SUBJECT: DAVIS-BESSE NUCLEAR POWER STATION, UNIT 1 - REQUEST FOR
RELIEF FROM AMERICAN SOCIETY OF MECHANICAL ENGINEERS BOILER
AND PRESSURE VESSEL CODE REQUIREMENTS FOR THE THIRD
10-YEAR INTERVAL INSERVICE INSPECTION PROGRAM (TAC NO. MB5849)

SAFETY EVALUATION BY THE OFFICE OF NUCLEAR REACTOR REGULATION

REQUEST FOR RELIEF NO. RR-A2

DAVIS-BESSE NUCLEAR POWER STATION, UNIT 1

Figure 1 Sketch depicting Code-required axial (1 and 2) and circumferential (3 and 4) scanning directions.

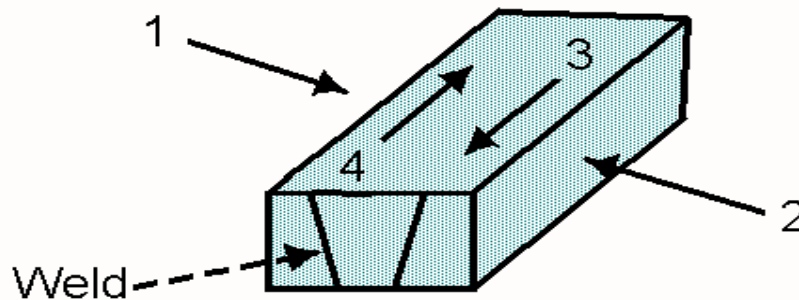
The examination volume for the Reactor Head-to-Flange Weld is defined in Figure IWB-2500-5. The examination volume can be scanned along the weld axis from two

directions. However, due to the extreme angle of the transition from the curvature of the head base material to the flange, access for scanning perpendicular to the weld axis is restricted to only the head side of the weld. From the head side of the weld, the service structure support skirt restricts scanning a portion of the examination volume with one of the two required angle beams. Scanning with the other required angle beam is not affected by the service structure support skirt.

Figure 2 Cross-sectional view of Weld WH-7 showing weld area (2) and base metal examination (1 and 3) zones.

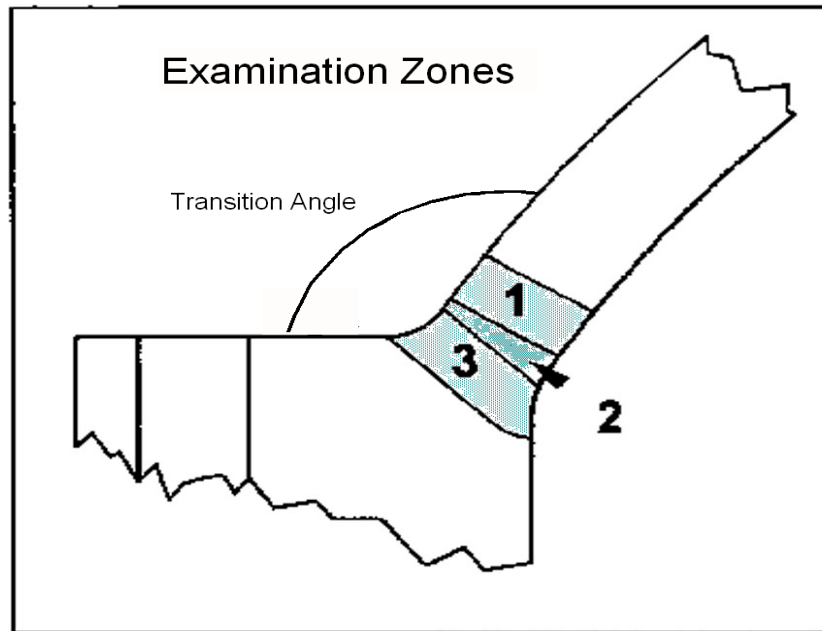
The Code requires essentially 100 percent volumetric coverage of RPV closure head-to-flange Weld WH-7 at DBNPS. The volumetric examinations are required to be performed by using several ultrasonic sound beams (at the proper angles within the material) that are directed both perpendicular and parallel to the weld. The *ultrasonic scans* are applied from the outside surface of the component, and should be conducted from each side of the weld, and across the surface (crown) of the weld. The intent of these requirements is to increase the likelihood of flaw detection by interrogating the component with multiple sound fields in order to find potential service-induced degradation that produces reflecting surfaces at various angular orientations relative to the weld and the heat-affected zone in the base material.

The component consists of an ASTM A-508, Class 2 forged ring (RPV bolting flange area) attached with a full penetration weld to an ASME SA-533, Class 1 forged, dome-shaped head. The cross-sectional geometry of the component at Weld WH-7 (see Figure 2) produces a high transition angle between the flange and the domed head. Scanning from the flange side may not provide the necessary angular orientation to detect flaws that are expected to initiate from the inner or outer surfaces and grow along the general orientation of the weld. In addition, the location of three closure head lifting lugs and a stamped directional marker (see Figures 3 and 4) further restrict access for ultrasonic examination. For these reasons, the component configuration does not allow the licensee to obtain the full Code-required volumetric coverage from both sides of the weld. For the licensee to achieve 100 percent volumetric coverage, the RPV closure head would have to be redesigned and modified. This would place a significant burden on the licensee, thus the Code-required 100 percent volumetric examination is impractical for Weld WH-7.

As shown on the sketches and technical descriptions provided by the licensee, a substantial amount (approximately 80 percent) of the Code-required examination volume can be obtained with the perpendicular, parallel and 0° ultrasonic scans performed from the head side of the weld. Apart from the Code volumetric examinations, the licensee also performs a separate 65° shear wave ultrasonic inspection from the head side of the weld to produce a sound field nearly perpendicular to the weld/base metal interface (in Figure 2, this is the black line between zones 1 and 2, and separating zones 2 and 3), as recommended by NRC Regulatory Guide 1.150 *Ultrasonic Testing of Reactor Vessel Welds During Preservice and Inservice Examinations*, Revision 1, February 1983. In addition to the volumetric examinations of this weld, the licensee conducts the essentially 100 percent Code-required surface examinations on the outside of the component. While the licensee cannot meet the Code-required 100 percent volumetric examination coverage, the limited examinations completed should detect any general patterns of degradation that may occur in the areas covered, providing reasonable assurance of the continued structural integrity of this weld. Therefore, pursuant to 10CFR50.55a(g)(6)(i), it is recommended that relief be granted.
